ARBORICULTURAL ASSESSMENT – BUILDING B

s. 96 Proposal for Approved Development:

Stage 1 Works, 120-128 Herring Road, Macquarie Park, NSW

10 August, 2012

Figure 1 Shows the SRZ and TPZ of T22 and the likely encroachments dues to piling and excavation batter. Drawing ref.A_B 232, Section BB, marked up by C. Mackenzie. Drawing not to scale.

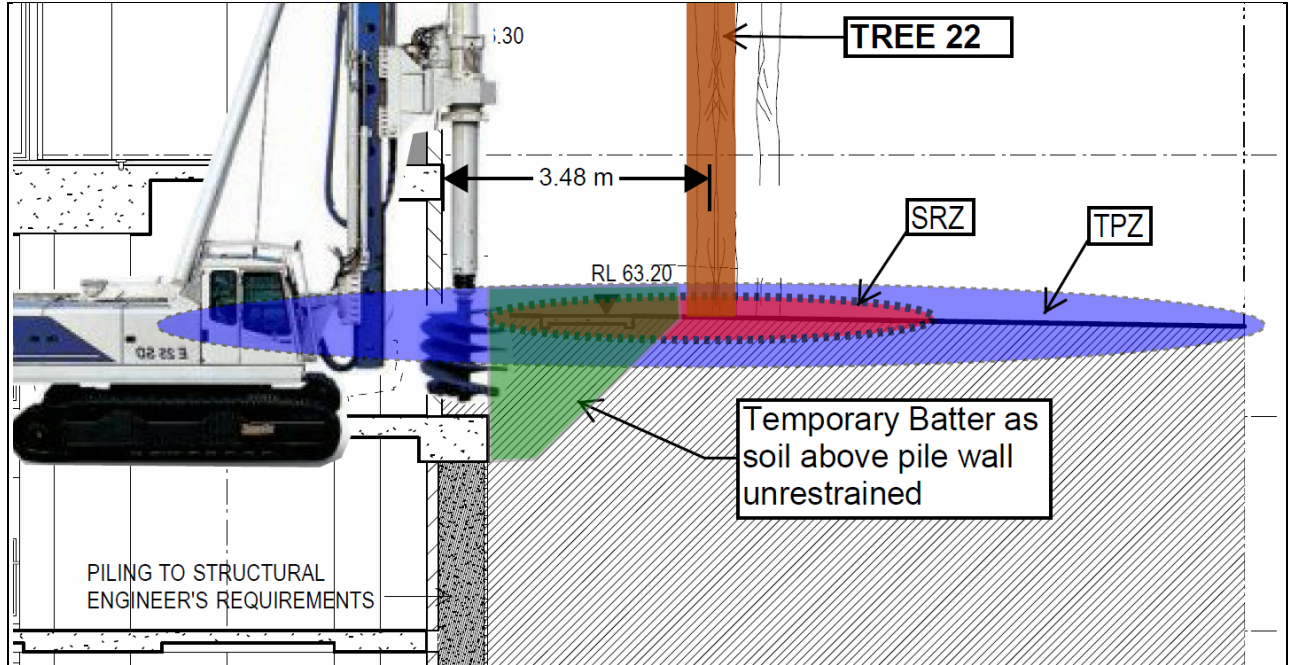
18. In terms of construction access and safety there is a requirement for some batter of the excavation. The batter shown in Figures 1 and 2 below could potentially be reduced, but this would not be sufficient to avoid a substantial SRZ encroachment.

Figure 2
Shows the SRZ 's of the three trees (red, dashed circles) and the identified encroachments.
Set-out plan, marked up by C. Mackenzie. Drawing not to scale.

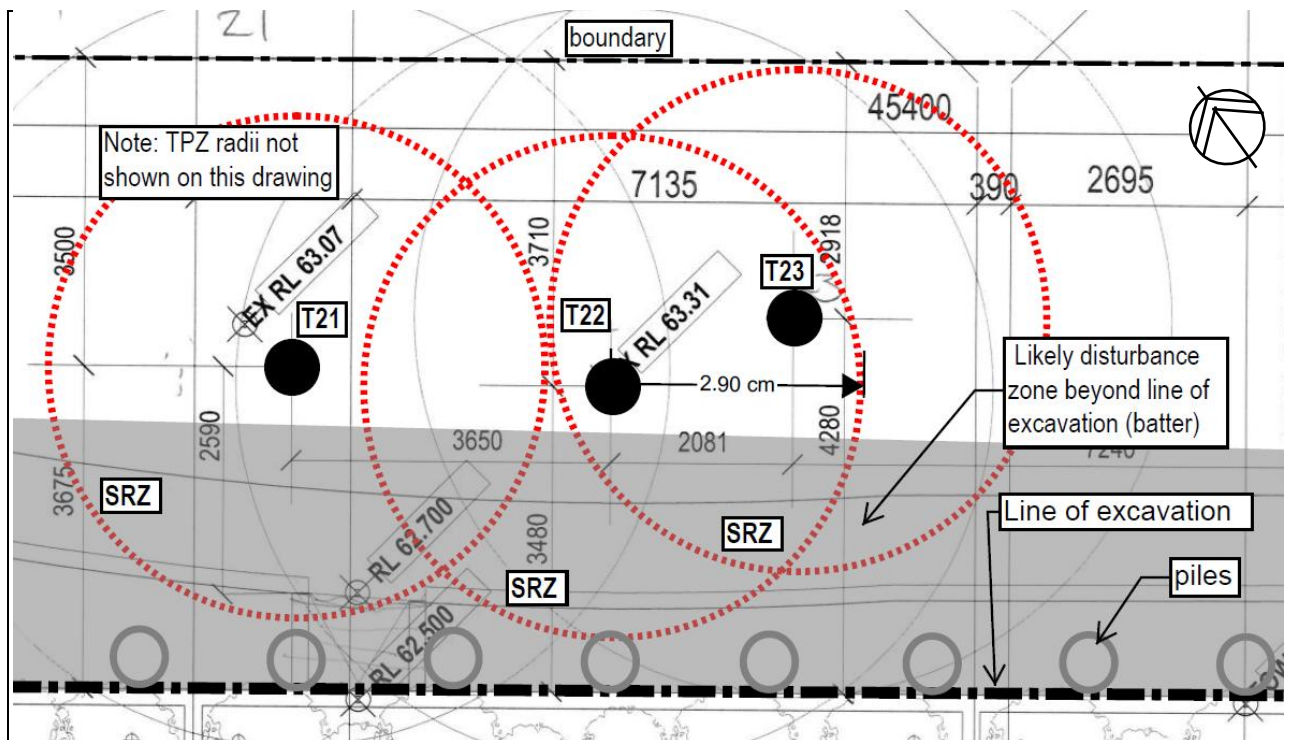
19. *Root mapping*⁷ was discussed during the onsite meeting between UFA and TG. Whilst UFA believes there is potential to reduce the excavation batter slightly and root mapping within the SRZ would confirm whether significant *woody roots*⁸ anchoring the trees would be affected, it is the opinion of UFA that the trees will suffer substantial *non-woody root*⁹ loss due to the building location within large portions of the tree's TPZ's.

20. The TPZ encroachments (including excavation batter) are estimated to be in the vicinity of 68m² or 41.75% (slightly more for T21 and slightly less for T23) which is a significant level of root loss from which the trees are unlikely to recover.

28. Trees 21, 22 and 23 (Grey Gums) – Remove due to identified significant excavation and construction impacts resulting from the approved development.
